# ADDENDUM No. 1

ITB No. 4618

## Landfill Scale and Entrance Improvements

# LANDFILL SCALE AND ENTRANCE IMPROVEMENTS

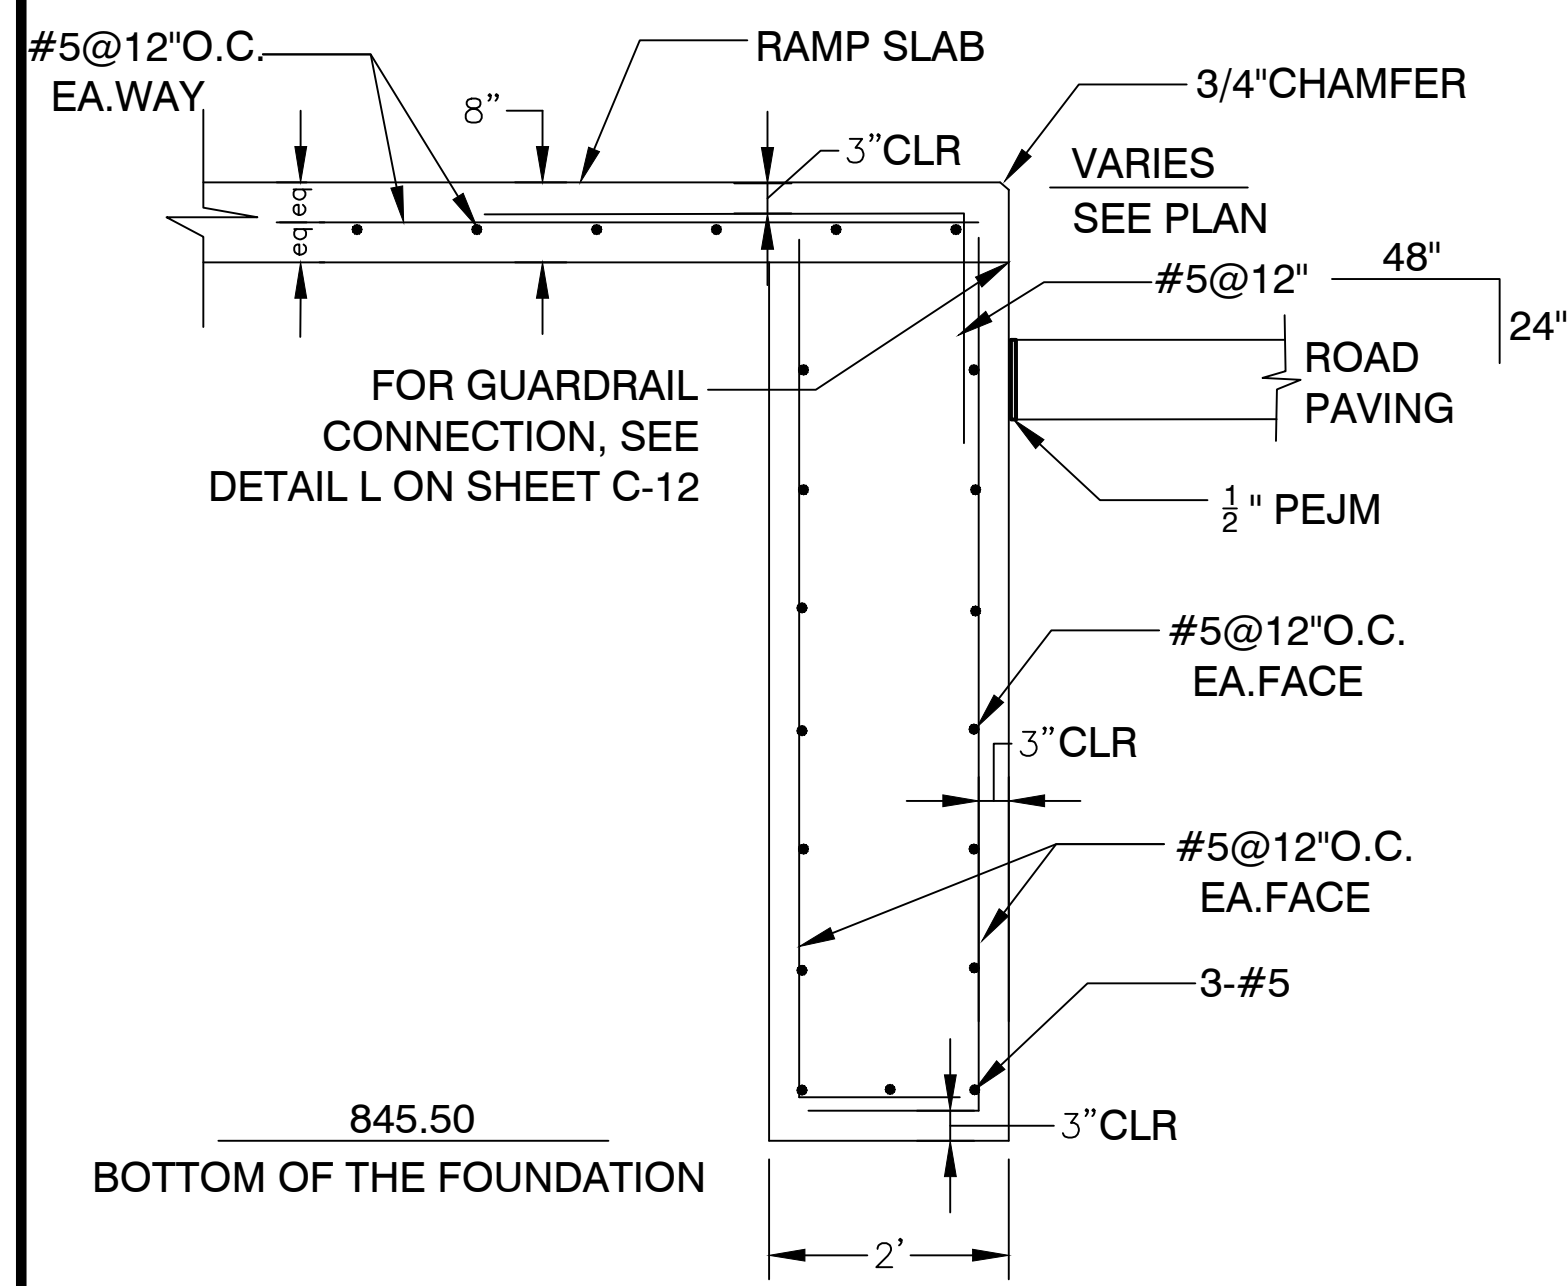
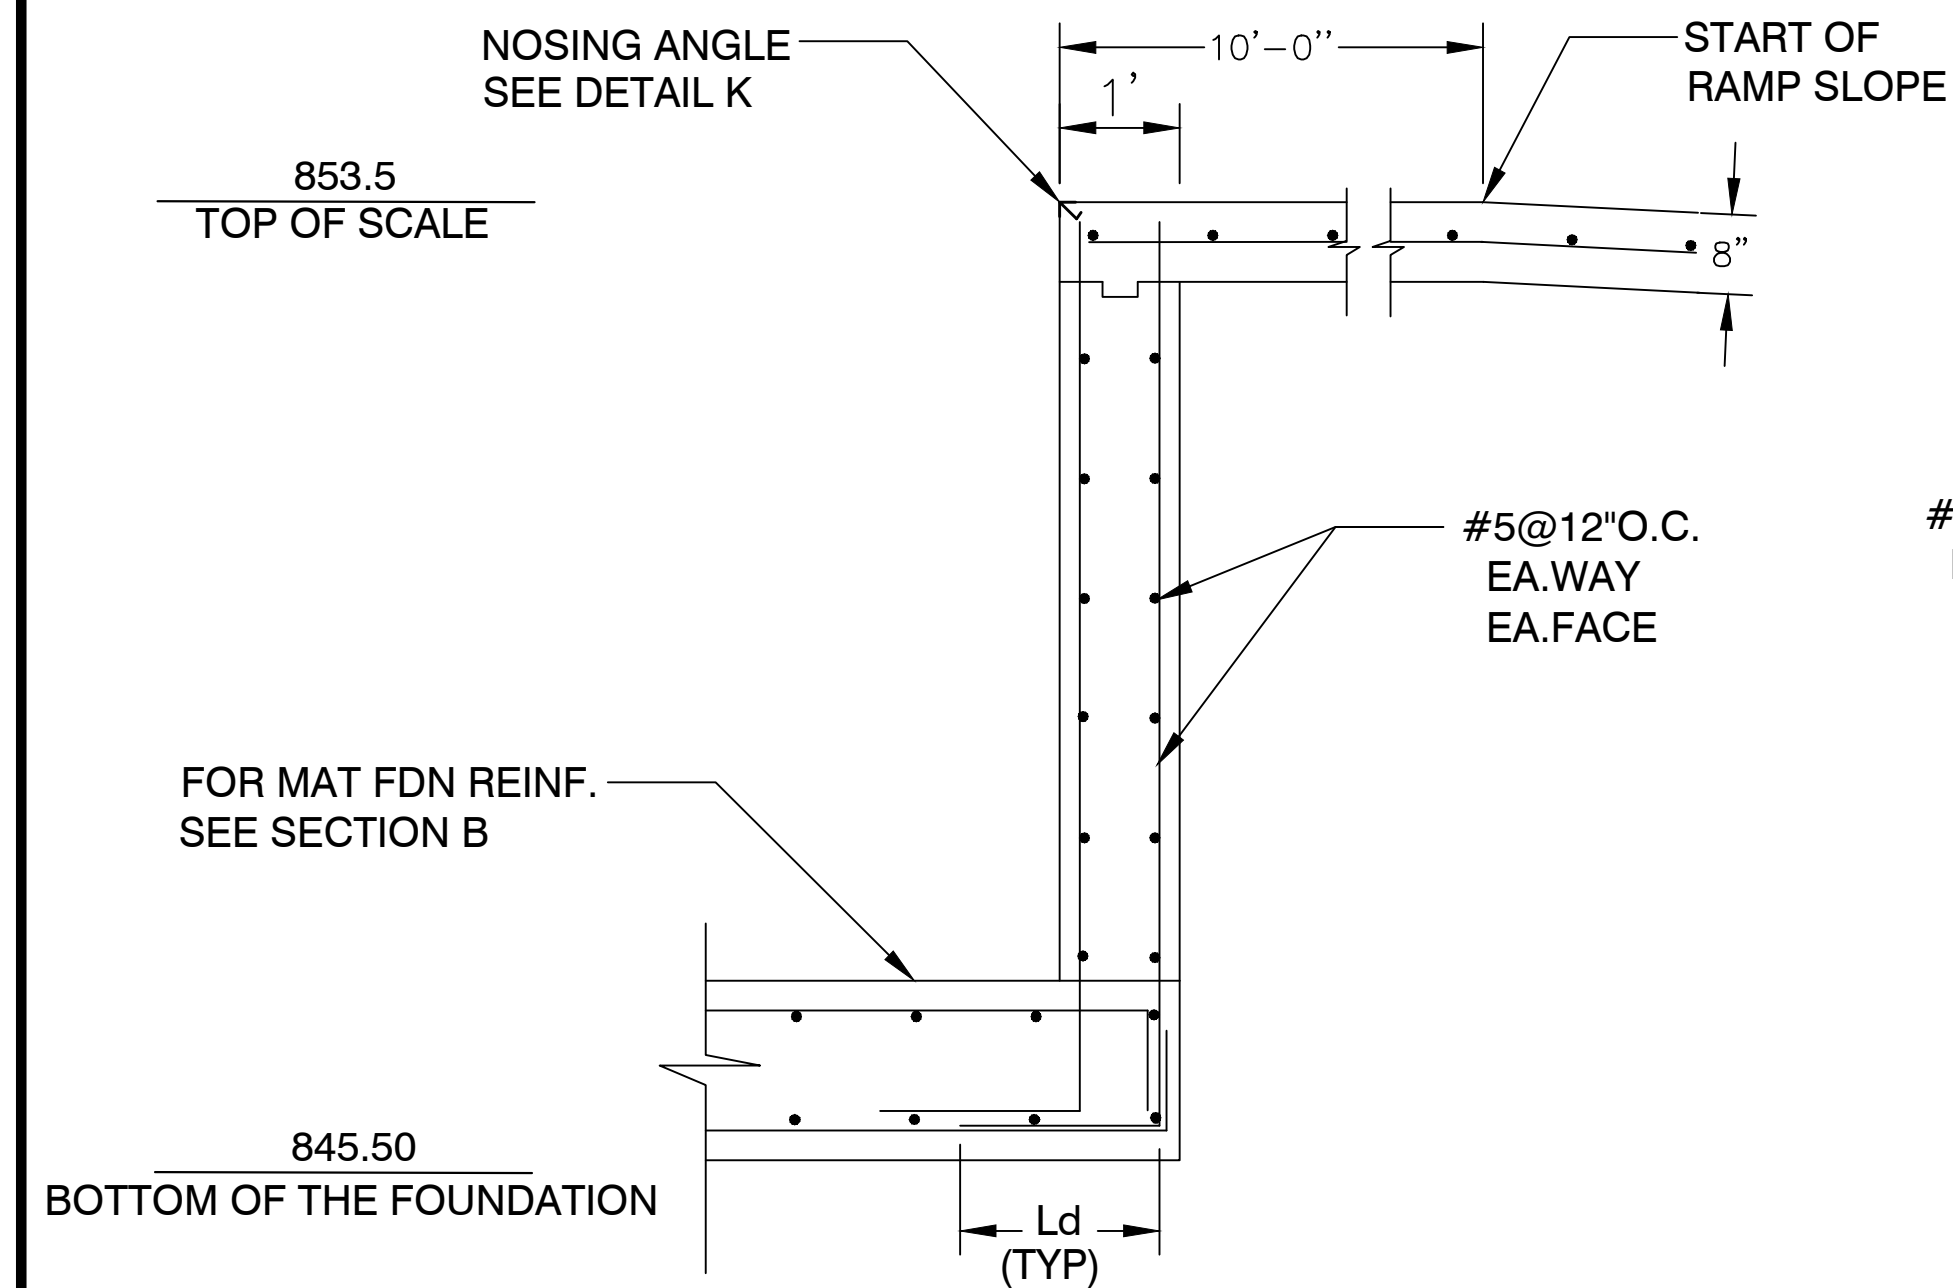
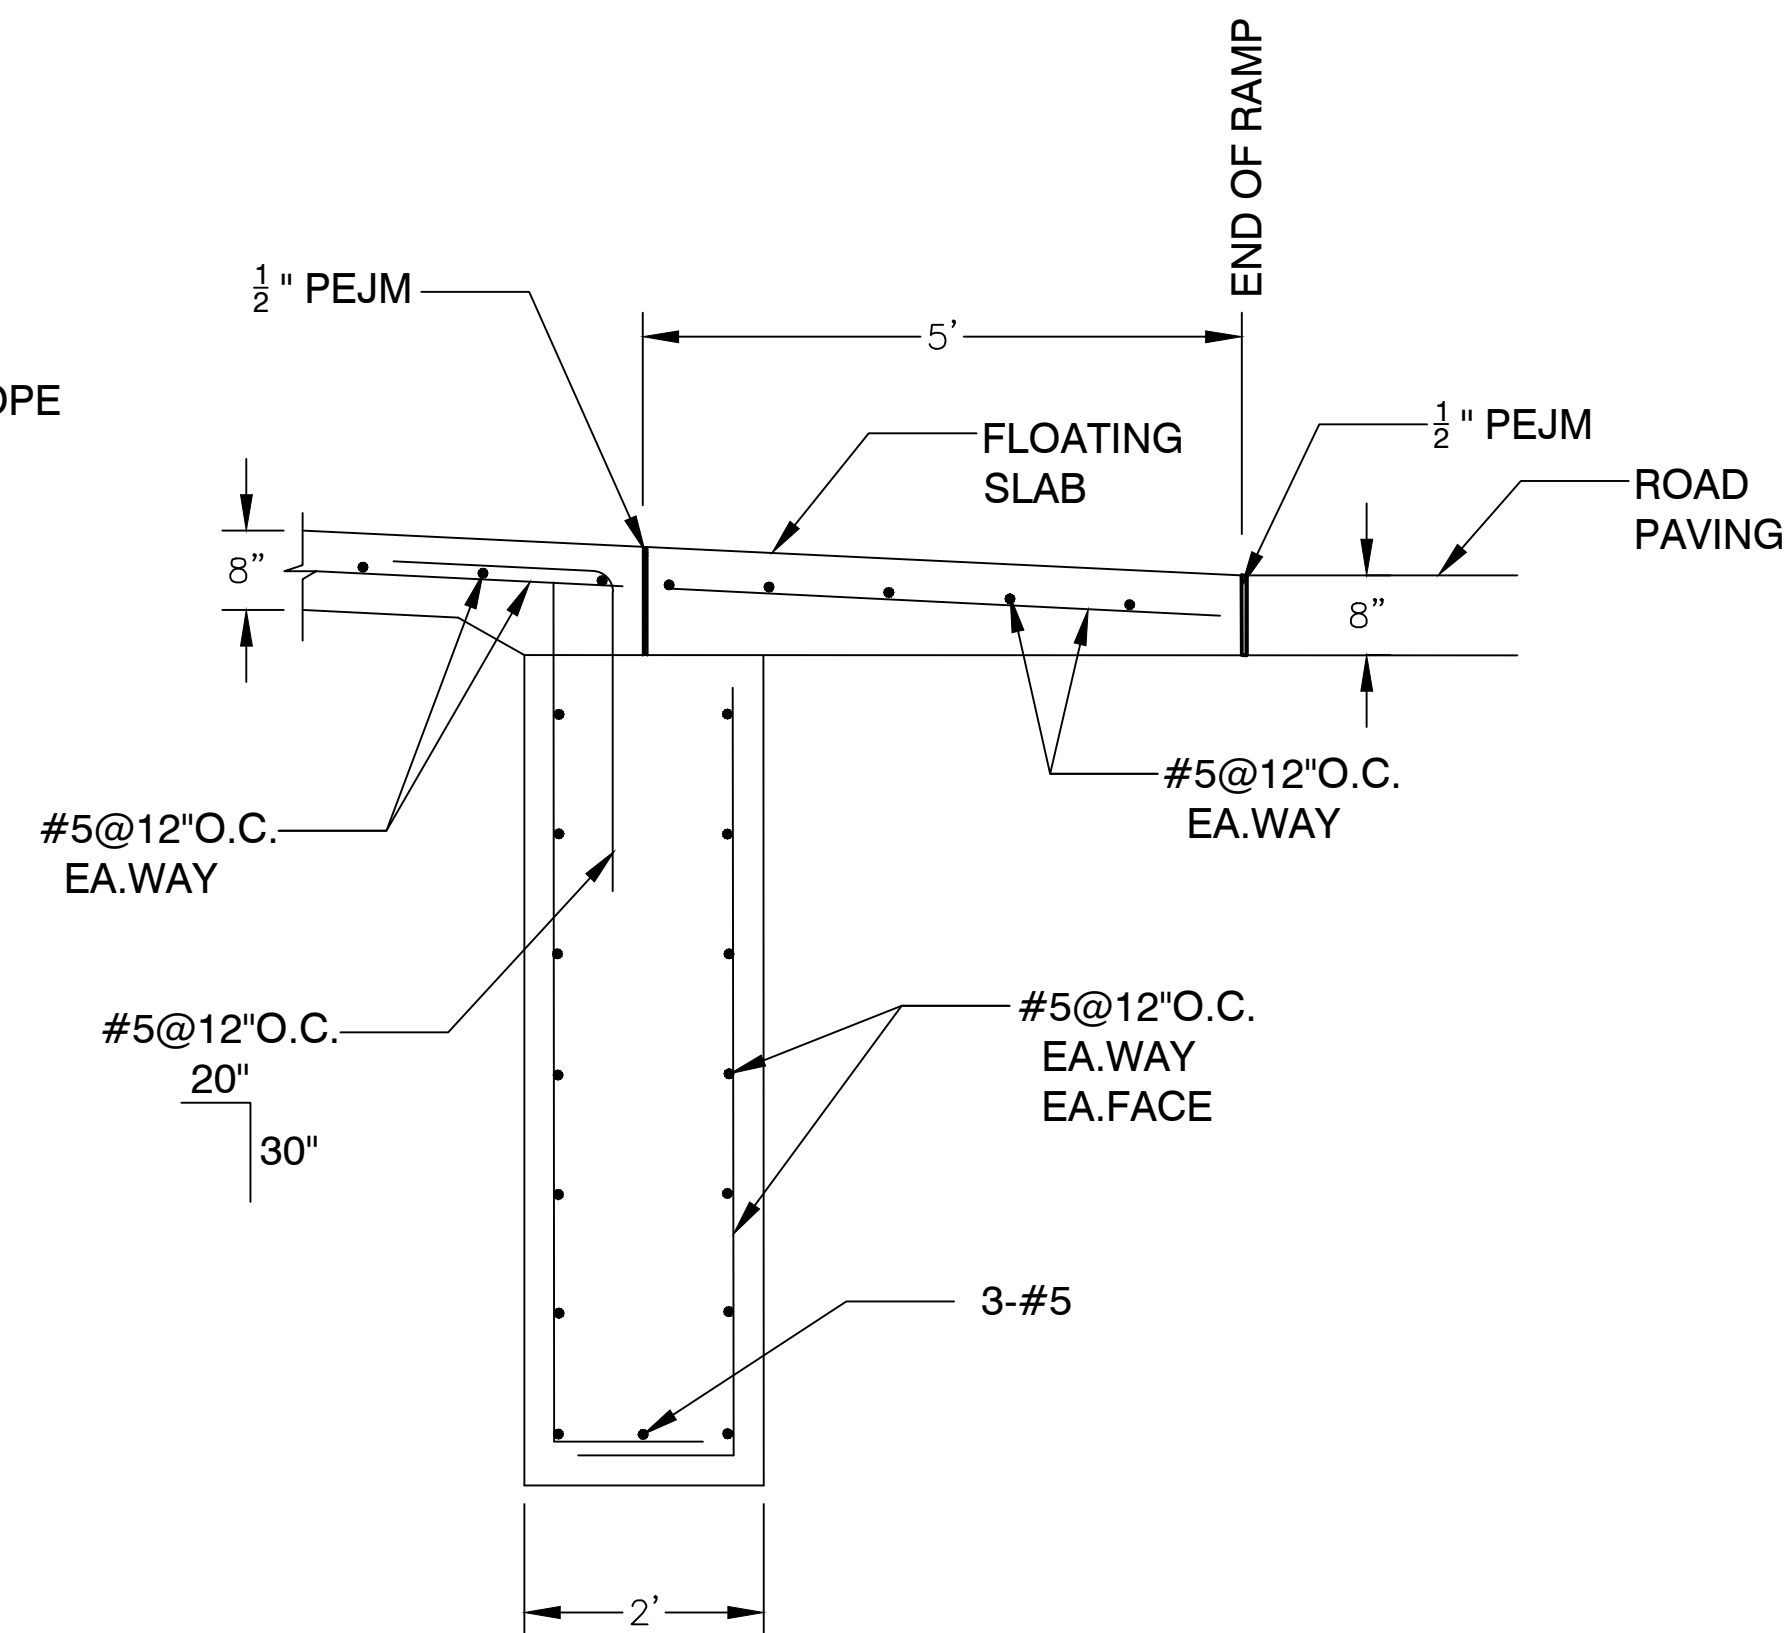
*Comment: The intent with this change is to simply replace the inaccurate ITB number, and revision date in the provided Bid Set Drawings (Plans) published with the ITB Document with the accurate Page C-01 through E-005 provided herein. In addition, the details for the ramp were updated.*

**L** GUARDRAIL CONNECTION  
NOTE: GUARDRAIL TO MATCH SCALE RAIL.

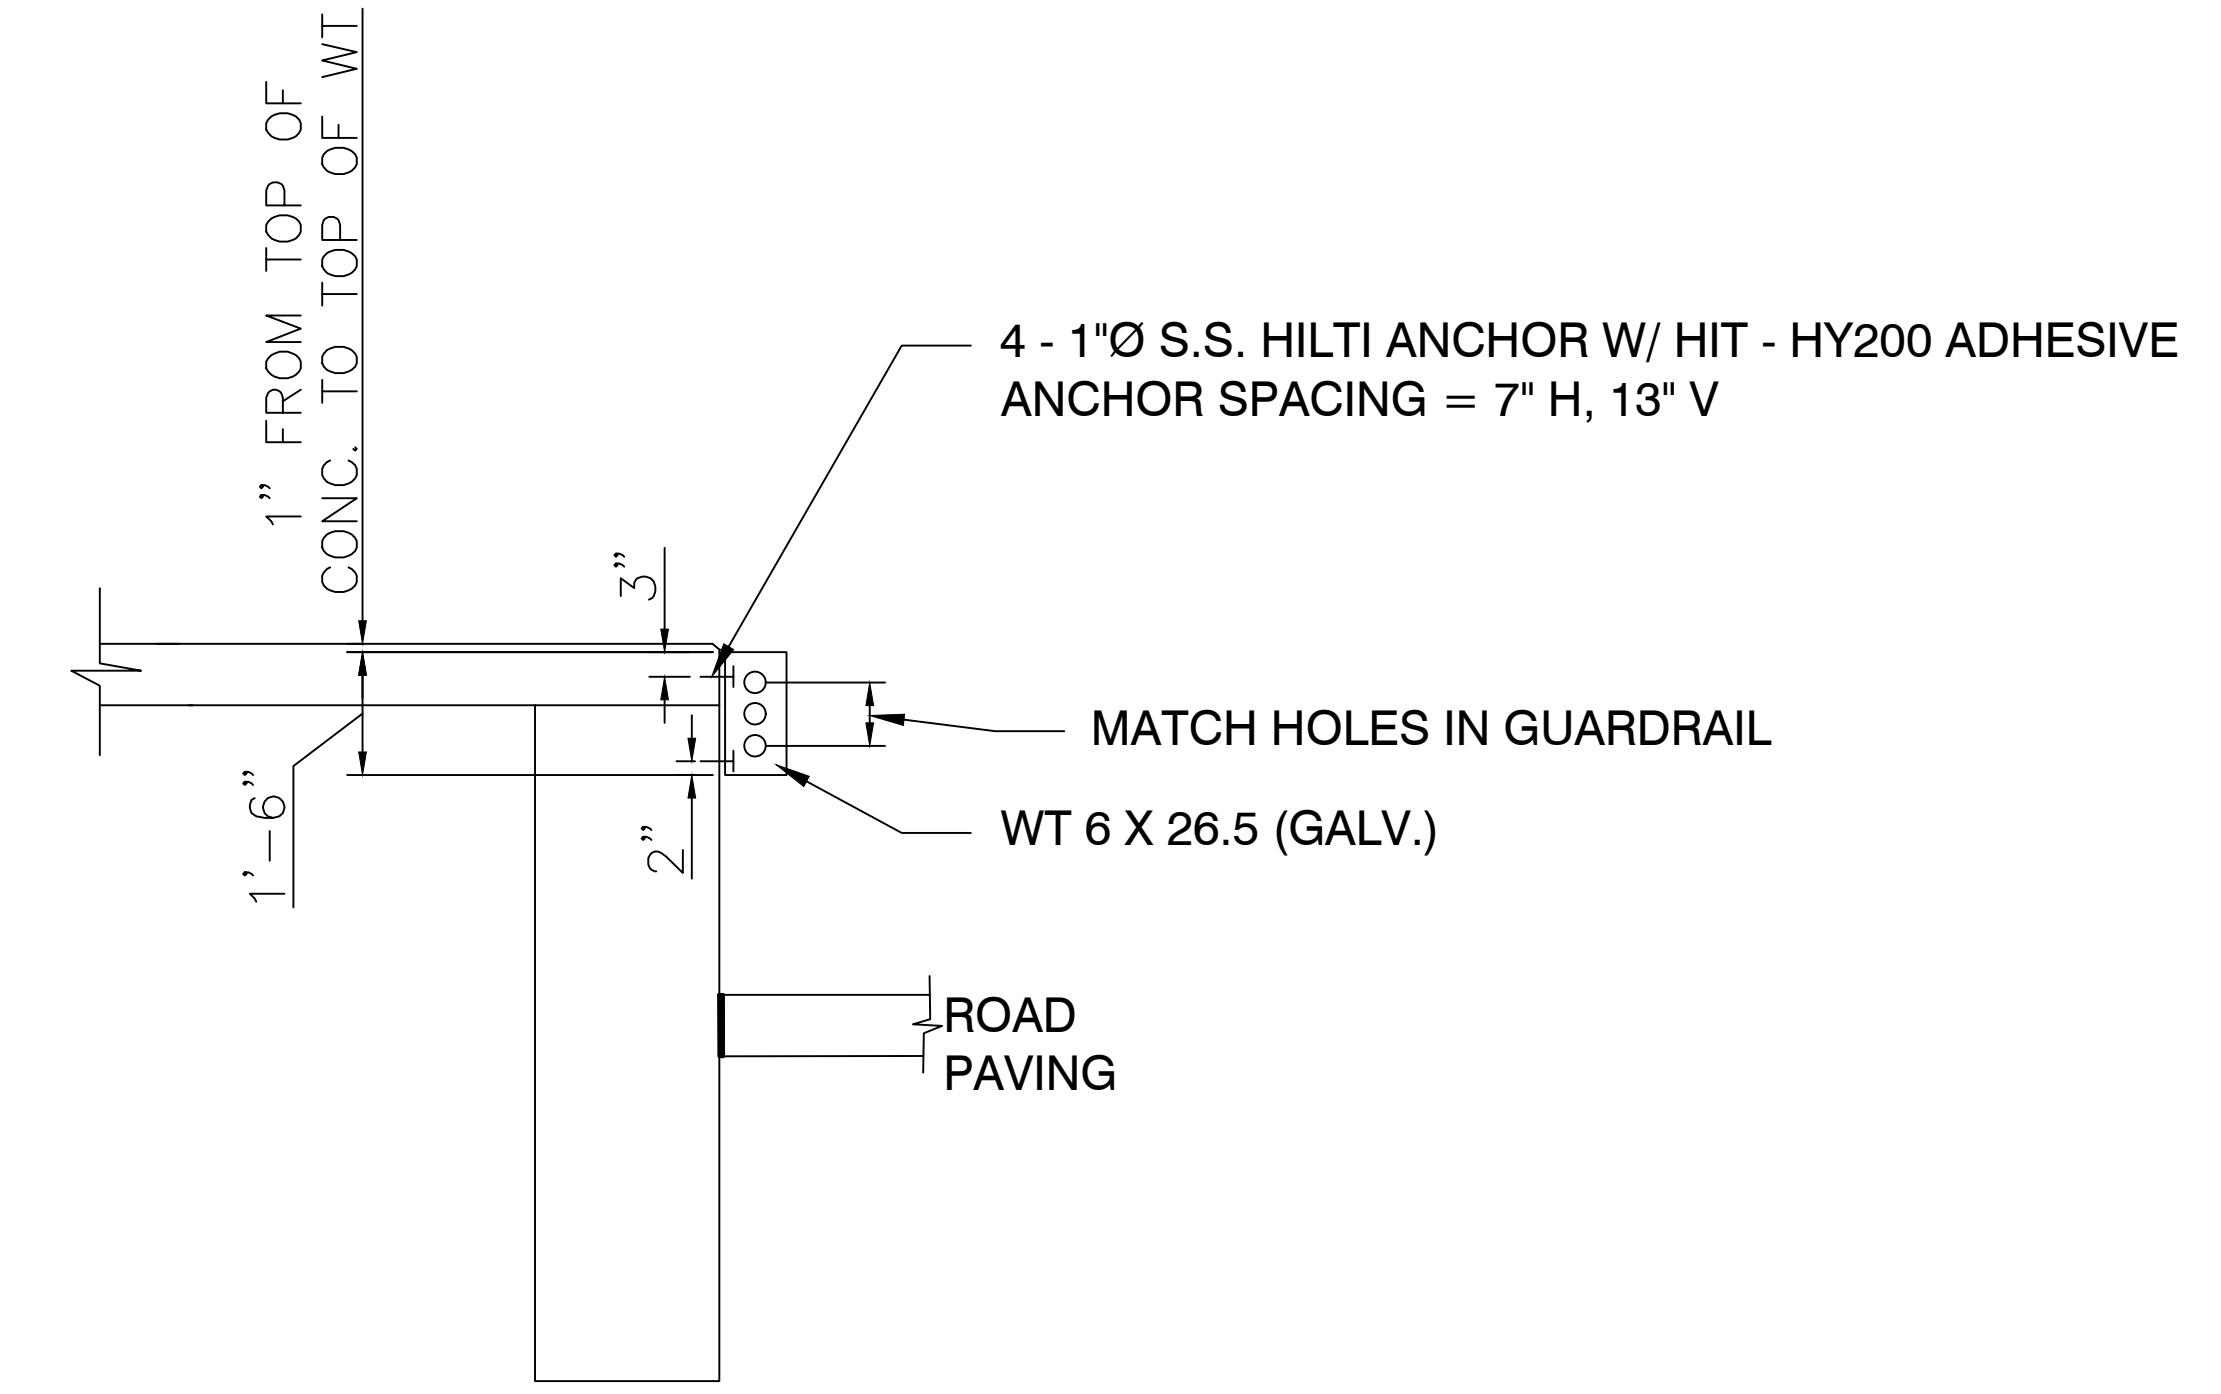
Please provide a specification section as it relates to the proposed guardrail. Also, please provide the coating requirements for the guardrail system and a connection detail (to the scale foundation system).

See notes on Sheet C-05 for the guardrail requirements. The guardrail shall be per the scale manufacturer requirements and shall be yellow galvanized steel.
